ECE/TRANS/WP.29/GRE/2008/42
11 July 2008

REGULATION No. 45
(Headlamp cleaners)

Proposal for draft Supplement 6 to the 01 series of amendments to Regulation No. 45

"Diagram of Measuring Points on a Screen

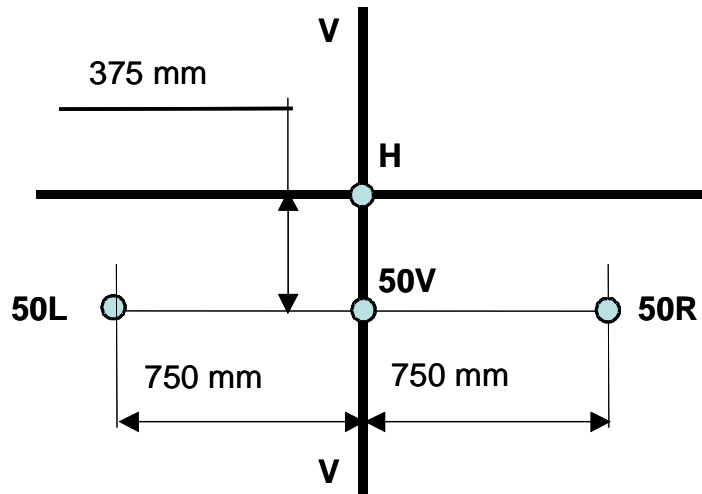
Paragraph 7.1., replace the existing diagram with the following:
